No. 0807-356
ATA Code 24-30

SUBJECT: ELECTRICAL POWER - MODIFICATION TO THE BATTERY BOX INSTALLATION

Service Instructions No 0807-356

Figure 1

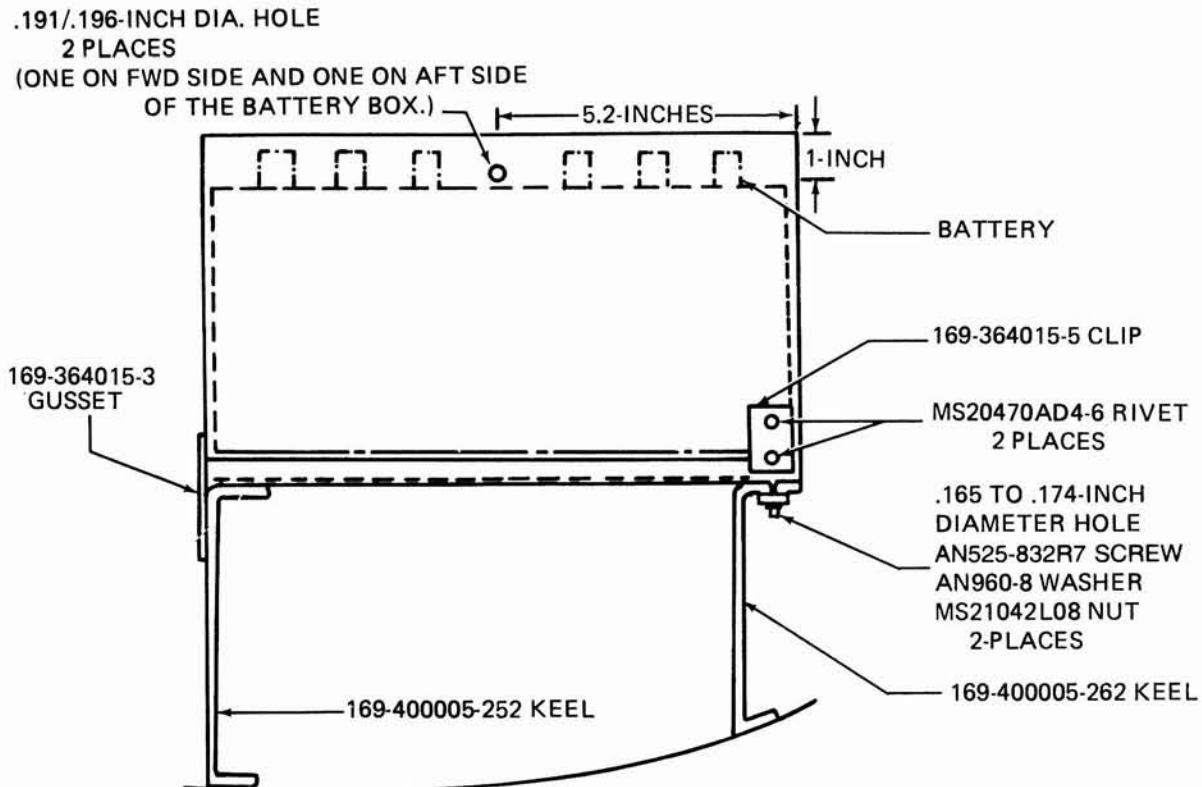
4. Install the 169-364015-5 clip with two MS20470AD4-6 rivets (rivets may be obtained locally) through the side of the battery box. Drill two .165/.174-inch diameter holes and install two AN525-832R7 screws, AN960-8 washers and MS21042L08 nuts down through the 169-400005-262 keel as shown in figure 1.

8. Starting at the outboard end of the battery box, measure in 5.2-inches and down 1-inch, and drill a .191/.196-inch diameter hole through the forward and aft sides of the battery box. (See figure 1.)

Figure 2

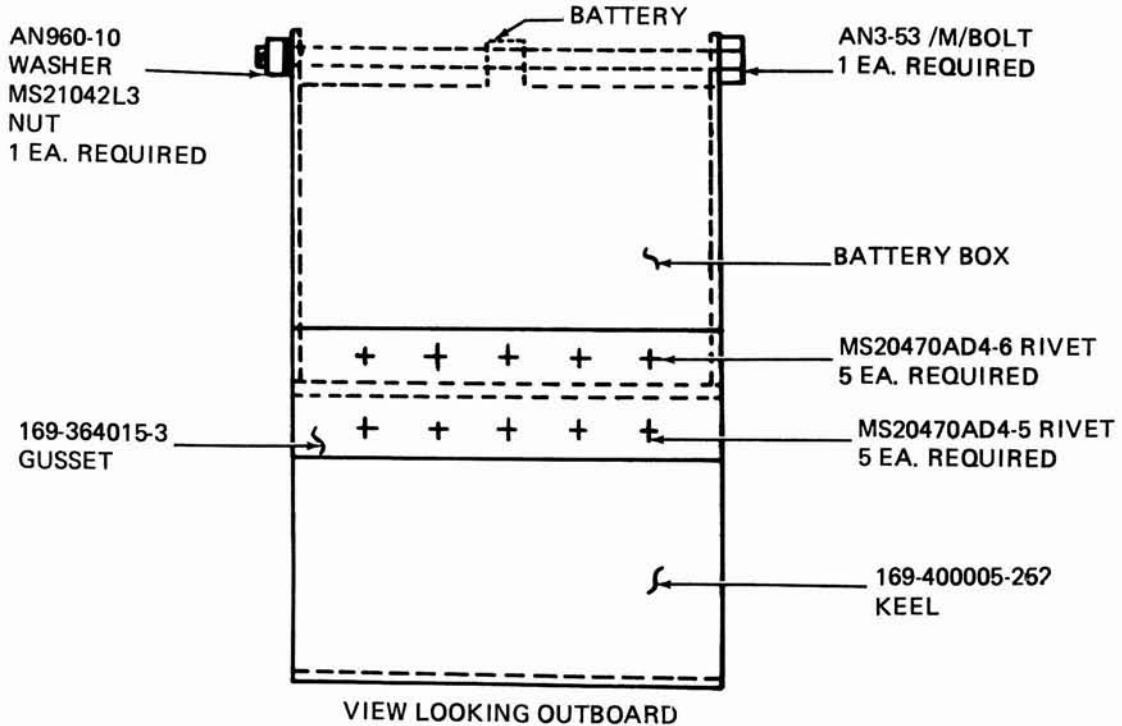
5. Align the 169-364015-3 gusset along the inboard base of the battery box with half of the gusset against the lower case and half against the 169-400005-252 keel. (See figure 2.)

7. Install the lower half of the gusset to the keel by drilling five .128/.133-inch diameter holes through the gusset and keel, and install with MS20470AD4-5 rivets. (Rivets may be obtained locally) (See figure 2.)

If the side of the battery box is not aligned with the keel it is permissible to shim between the 169-364015-3 gusset and the 169-400005-252 keel with 2024T3 aluminum alclad flat sheet. Attach the 169-364015-3 gusset and shim to the 169-400005-252 keel with AN525-832 screws of the appropriate length, AN960-8 washers, and MS21042L08 nuts in lieu of the MS20470AD4-5 rivets.
